RE: Addendum No. 6
RFP SCF25-1174
TED Wearable Duress System
Additional Questions, answers, comments. Floor Plans

SOUTHCENTRAL FOUNDATION
TUDOR & ELMORE DEVELOPMENT
ANCHORAGE, ALASKA

SHEET NO.
TN101C

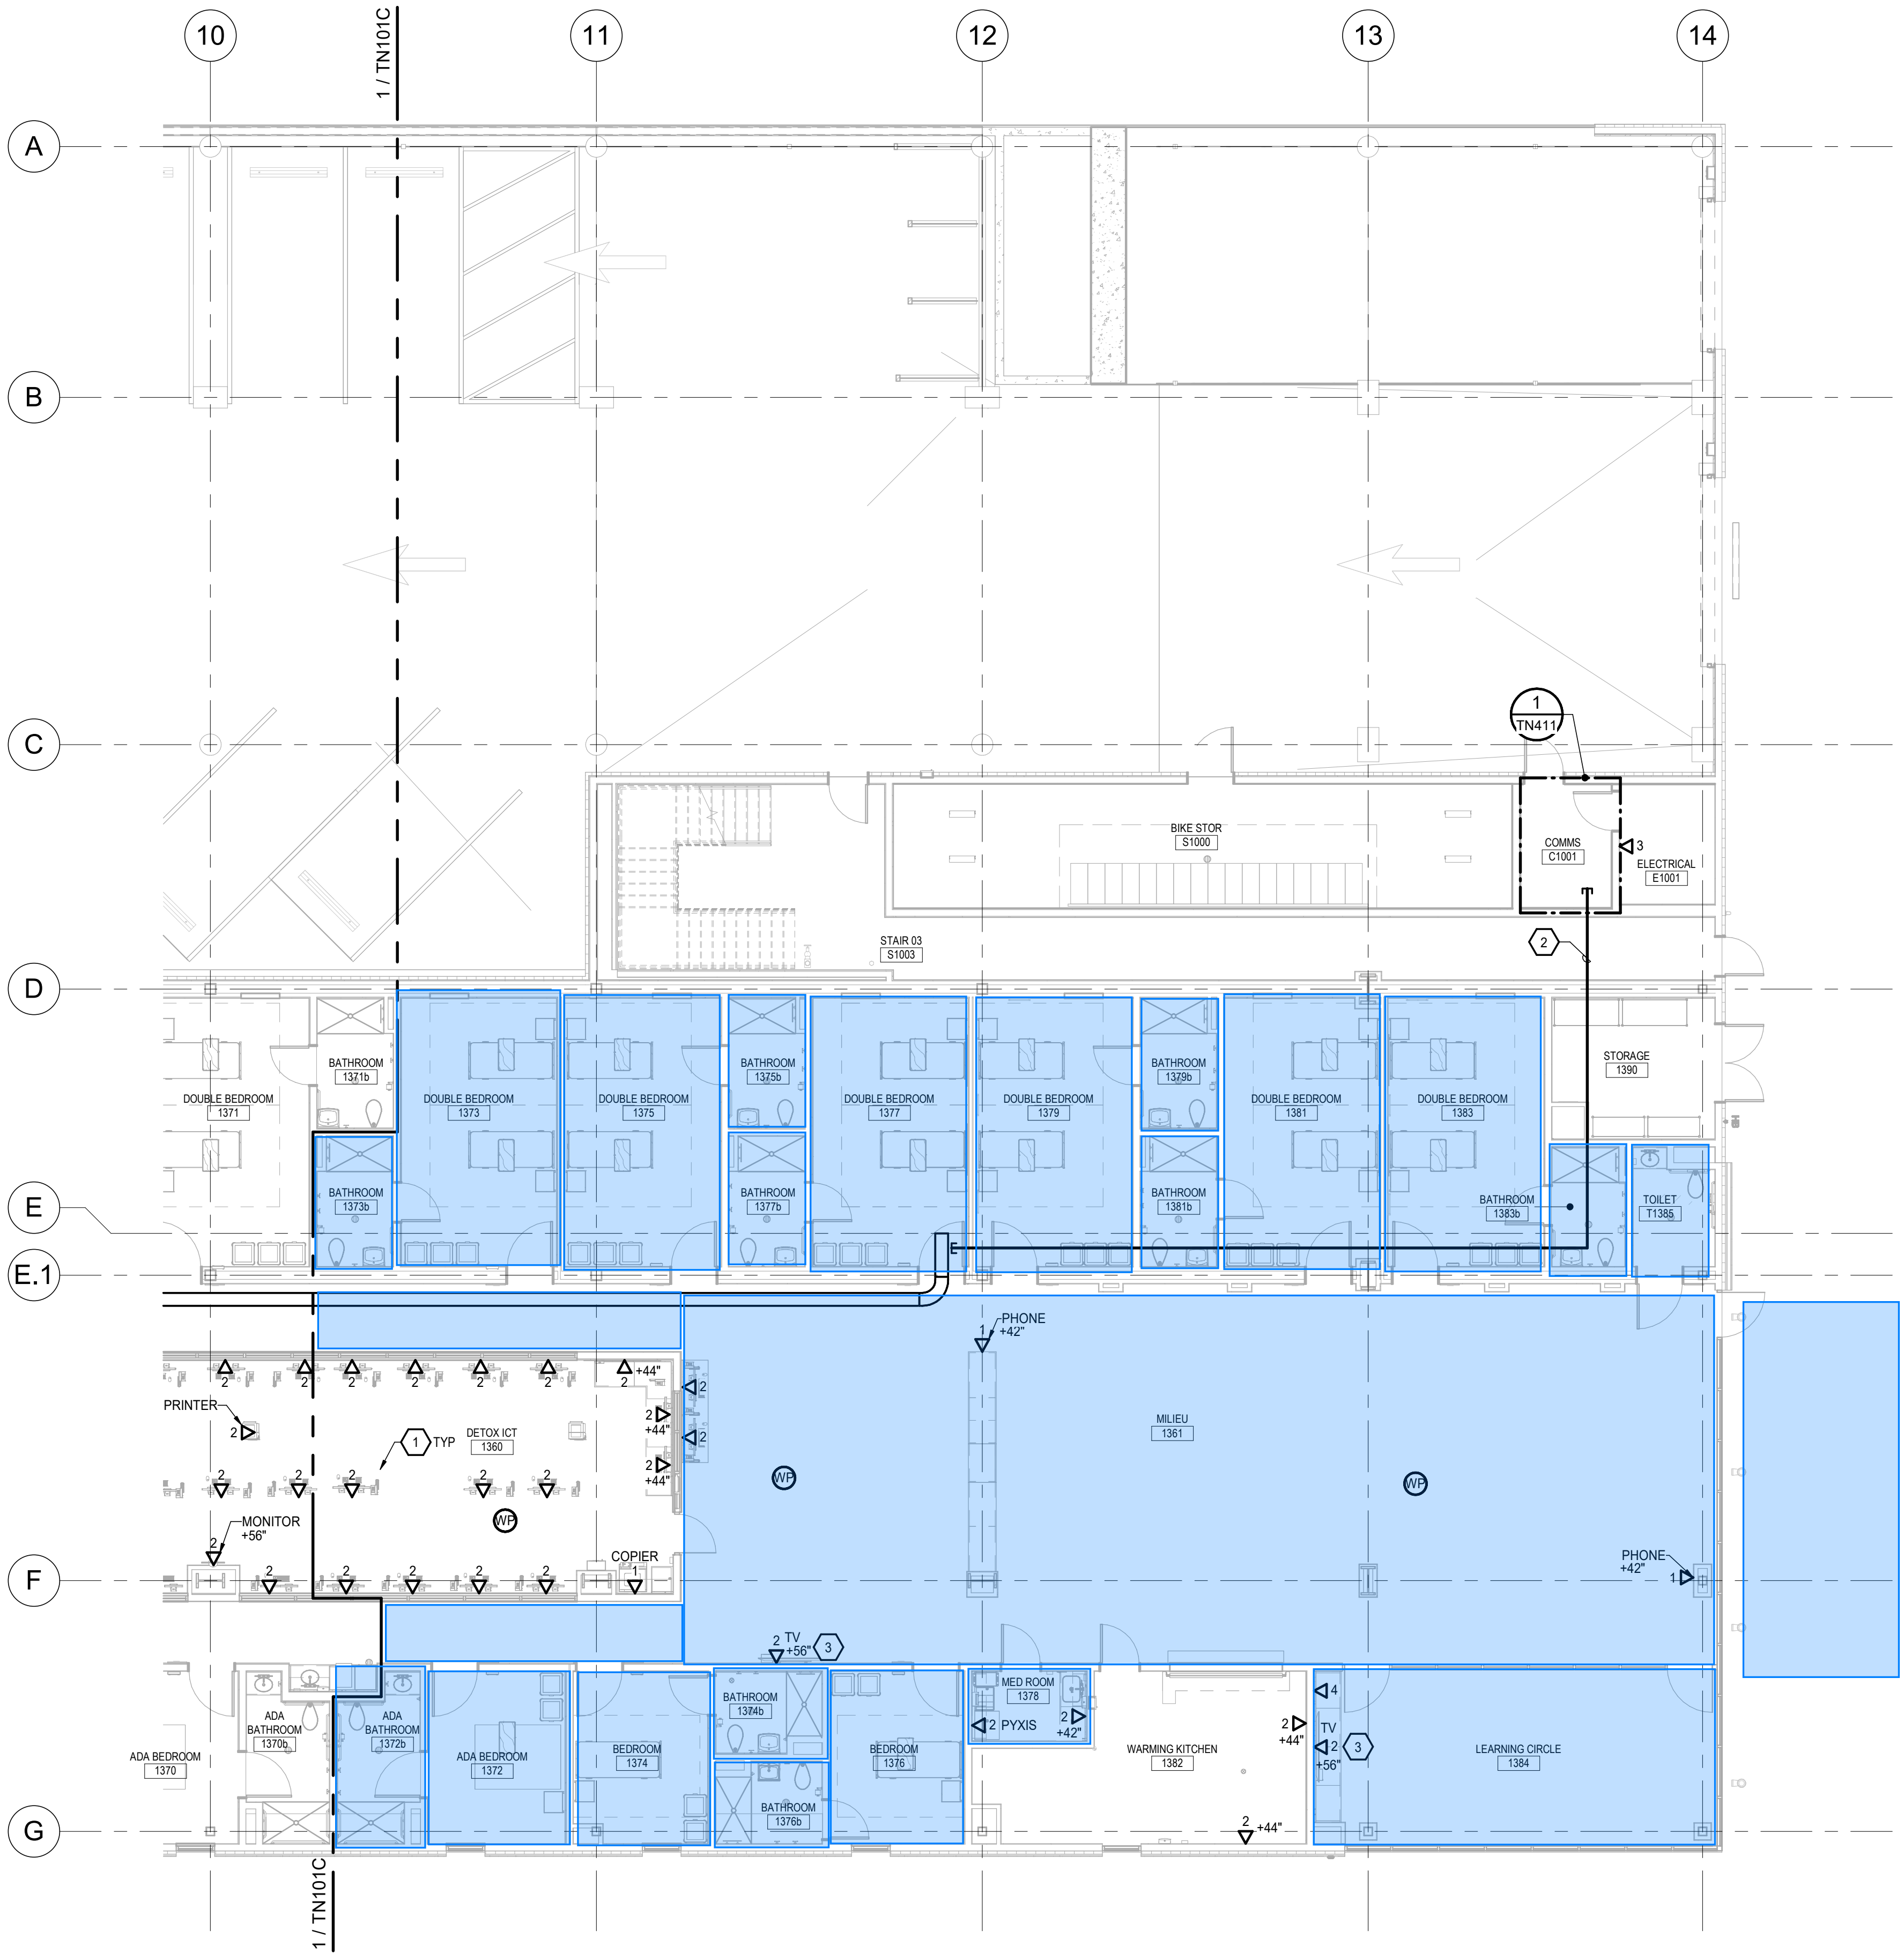
To include RLTS in detox yard
